Ref. No. 201512011
Petition No. 552REV

**REQUEST BERM USE
 (For Parking Only)
 INTO JOY RD.
 AT 14516 JOY RD.**

**CITY OF DETROIT
 CITY ENGINEERING DEPARTMENT
 SURVEY BUREAU**
 JOB NO. 01-01
 DRWG. NO. X 552

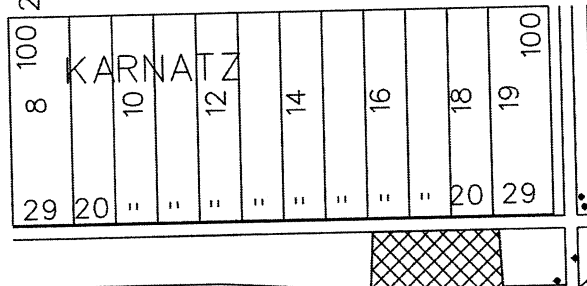
- (X) Involved; have no objection to the request for berm use (for parking only) into Joy Rd. at 14516 Joy Rd. as shown on drawing no. x552 dated 03-12-2015 and revised on 3/11/2016.

- (1) In order to delineate the parking area and to make it safe for pedestrian and vehicular traffic adjacent to it, the petitioner shall be responsible to maintain the required continuous concrete stoppers that they have installed along the edge of the concrete berm adjacent to the grassy area just west of it, along the edge of the sidewalk just north of it, and along the edge of the paved roadway just south of it.

- (2) It shall be the petitioner's responsibility to maintain at all times, a minimum 6 ft wide clear sidewalk in front of 14516 Joy Rd.
